# Clonburriss T2

## Clarification of Further Information

CLB-T2-ZZZ-SW-DTM-RP-DBFL-CE-0005

October 2023

Figure 1: Water levels for Provided Storage and Required Storage. Extract from drawing CLB-1B-94-SW-DTM-DR-DBFL-CE-5005

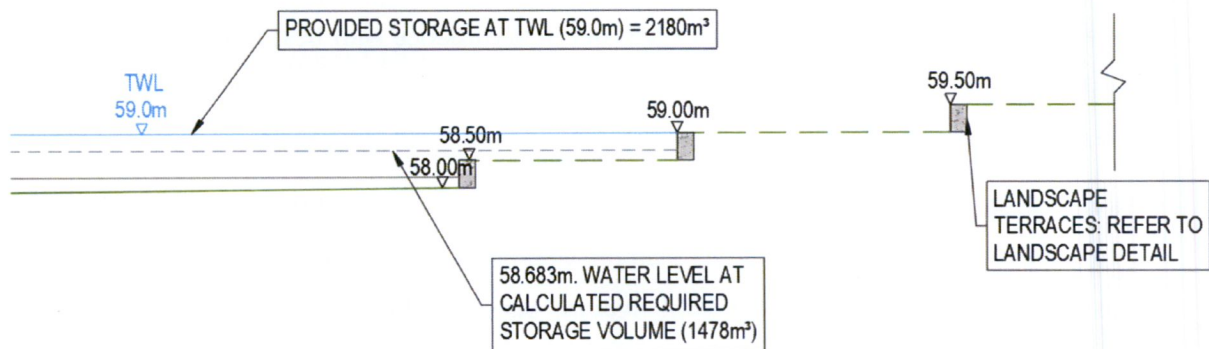
The applicant is requested to clarify what attenuation is provided in m<sup>3</sup> and what is required in m<sup>3</sup> for proposed development.

Updated Drawing CLB-1B-94-SW-DTM-DR-DBFL-CE-5005 includes a plan and section drawing of the attenuation feature complete with all water levels. A schematic extract is presented below in Figure 1

As described in response to Item 1.1, Proposed Storage volume significantly exceeds minimum calculated volume. Updated Drainage calculations (see Appendix A) have calculated a minimum required storage volume of 1478m<sup>3</sup> would be required which would correspond to a water level of 58.683. The storage actually proposed is 2180m<sup>3</sup> with a design TWL of 59.0m

Note the lowest building floor level within the subject development is 59.600m AOD and the floor level of the adjacent T1 development west of the proposed attenuation pond is 59.900m AOD, providing sufficient freeboard over and above the proposed top of water level 59.0 for the attenuation pond.

Figure 2 – Extract from Clonburris Surface Water Masterplan Catchment Drawing indicating areas requiring onsite attenuation. Note only a portion of subject site classified as urban centre

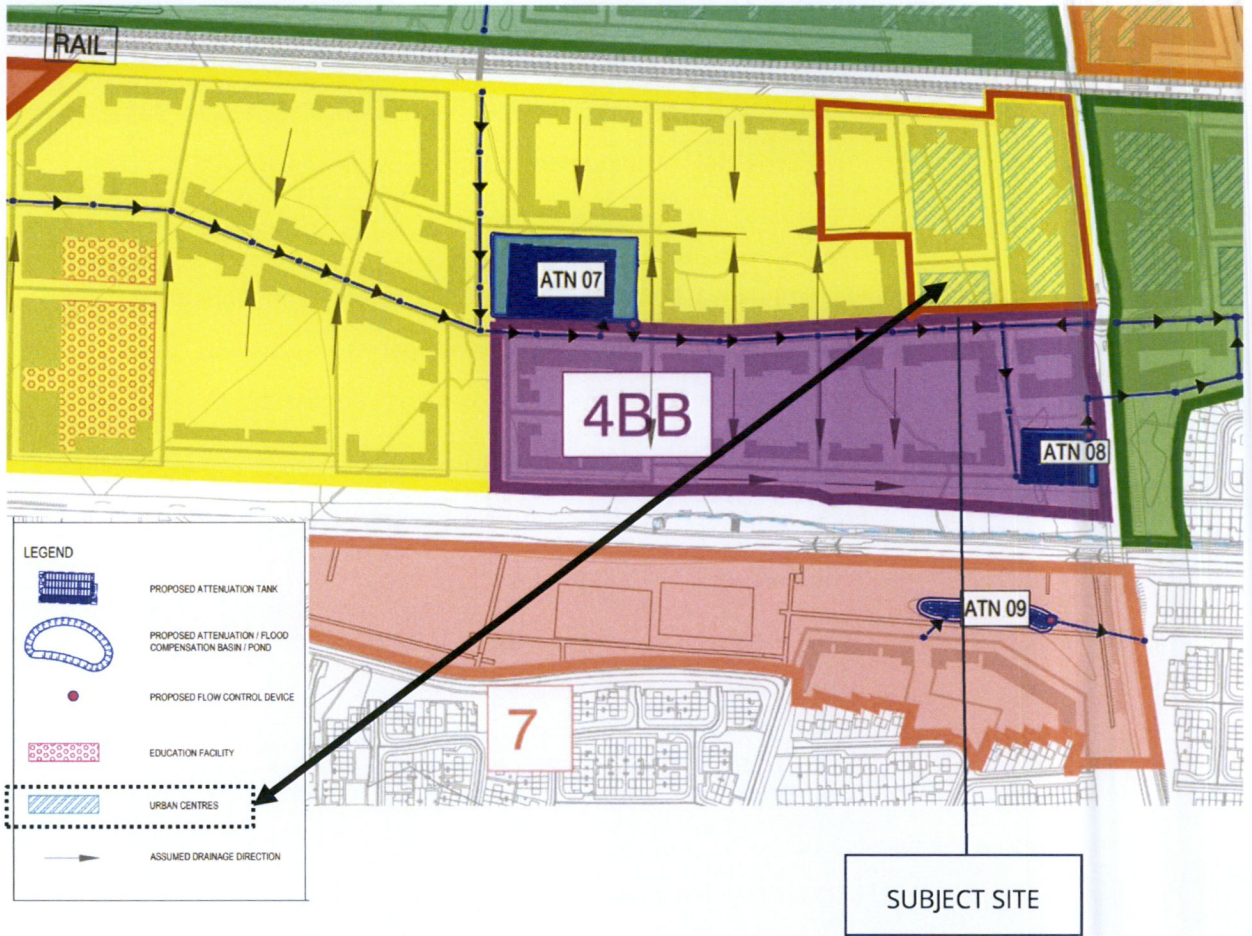
The applicant is requested to clarify what areas are residential that can be attenuated in the general Clonburris Attenuation plan and what areas are schools, and commercial areas that require on site attenuation. Show how surface water attenuation relates to Surface Water Management Plan for Clonburris 2020. Attenuation should be by means of SuDS.

The proposed drainage strategy is fully aligned with Surface Water Management Plan for Clonburris. As set out in the masterplan, only areas identified as Urban Cores or Education sites require onsite attenuation, all other areas can drain directly to the regional attenuation. As required by the SWMP Catchment plan, the urban centre (CUC3) portion of the site is attenuated locally within the development. The proposed catchment area for the urban core is indicated as Catchment 1 on drawing CLB-1B-94-SW-DTM-DR-DBFL-CE-1002.

Figure 4 - Drawing CLB-1B-94-SW-DTM-DR-DBFL-CE-1002 Proposed Surface Water Catchments

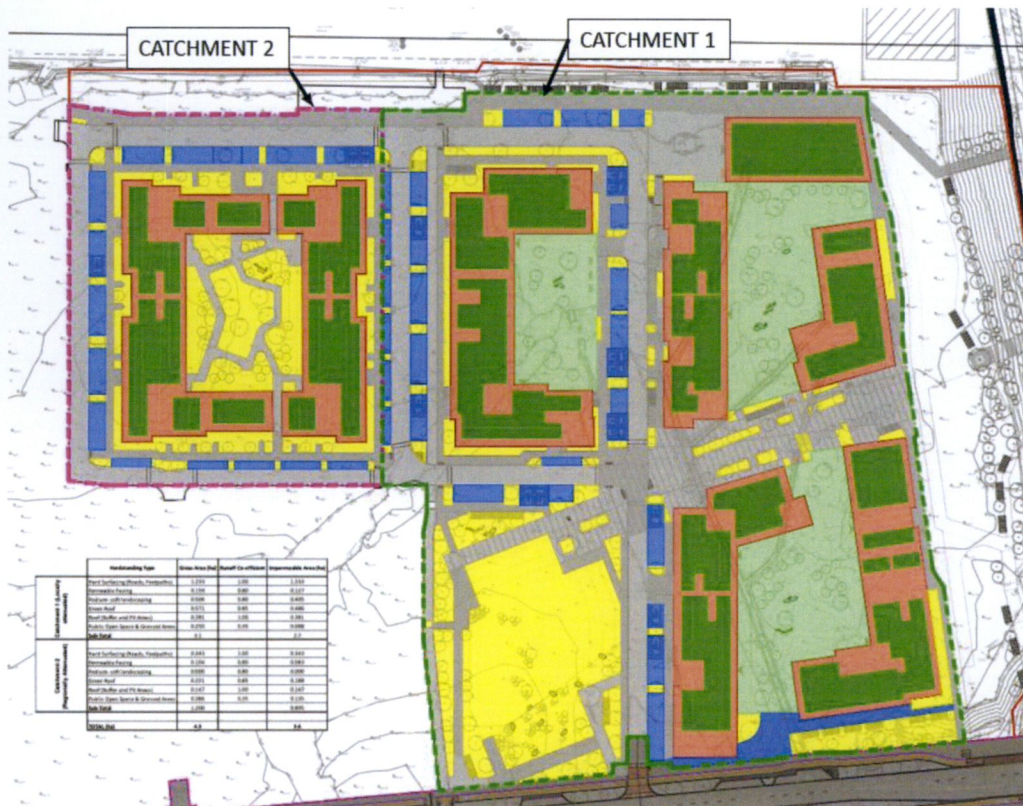
The applicant is requested to submit a revised report to show surface water attenuation calculations for proposed development. The applicant is requested to submit the area in m<sup>2</sup> of hard standing, buildings, roads, green roofs if any, permeable paving, grass and their respective run off coefficients.

Please refer to drawing CLB-1B-94-SW-DTM-DR-DBFL-CE-1002 as issued for Planning, which shows the area of hard standing, buildings, roads, green roofs, permeable paving, grass and their respective run off coefficients. This is unchanged since previous submissions.

All attenuation for Catchment 1 of the proposed development is within the open attenuation pond, which is considered a high quality SuDS feature providing all four pillars of SuDS. It provides Amenity and Biodiversity value in addition to managing water Quality and Quantity. In addition SuDS tree pits are provided throughout the site.
